# Access Compliance Report

## Public Rights-of-Way

### (Curb Ramps)

Intersection ID: 12401	Main Street: MIDWOOD_PL	Cross Street: TIPPAH_AV	Location: SE
ADA ID: FF6CE8A9782F	Ramp Type: PerpDiag	Initial Pass/Fail: Fail	Overall Compliance: No
		Severity Score: 12.5

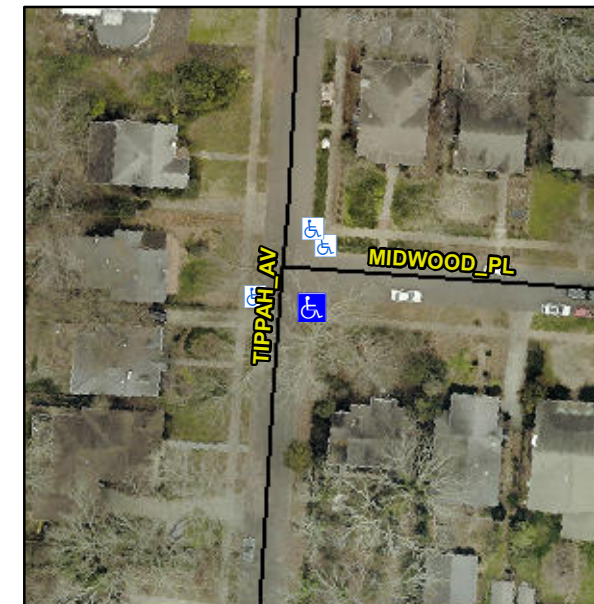
**Not Found, R304.2.2**

Compliance	Description	Data	Compliance	Description	Data
N/A	Ramp Length (in)	112.0	No	Ramp Slope (%)	8.7
Yes	Ramp Width (in)	57.0	Yes	Ramp XSlope (%)	0.9
N/A	Flare Type LT	N/A	N/A	Flare Type RT	N/A
N/A	Flare Slope LT (%)	N/A	N/A	Flare Slope RT (%)	N/A
N/A	Flare Traversable LT?	N/A	N/A	Flare Traversable RT?	N/A
N/A	Landing Length (in)	N/A	N/A	DWS Provided?	N/A
N/A	Landing Width (in)	N/A	N/A	DWS Contrast?	N/A
N/A	Landing Slope (%)	N/A	N/A	DWS Length (in)	N/A
N/A	Landing X Slope (%)	N/A	N/A	DWS Full Width?	N/A
N/A	Landing Curb? (Y/N)	N/A	N/A	DWS Offset (in)	N/A
N/A	Shared Landing?	N/A			
N/A	Gutter Ponding?	Yes	N/A	Gutter Slope (%)	N/A
N/A	Gutter Lip Ht (in)	N/A	N/A	Gutter X Slope (%)	N/A
N/A	Painted X Walk1?	No	N/A	Painted X Walk2?	No
	X Walk 1 Direction	To N		X Walk 2 Direction	To W
N/A	X Walk 1 Width (in)	N/A	N/A	X Walk 2 Width (in)	N/A
	X Walk 1 Slope (%)	6.5		X Walk 2 Slope (%)	0.1
	X Walk 1 X Slope (%)	1.3		X Walk 2 X Slope (%)	3.1

**Remove & Replace Curb Ramp With Two New Directional Ramps or Equivalent.**
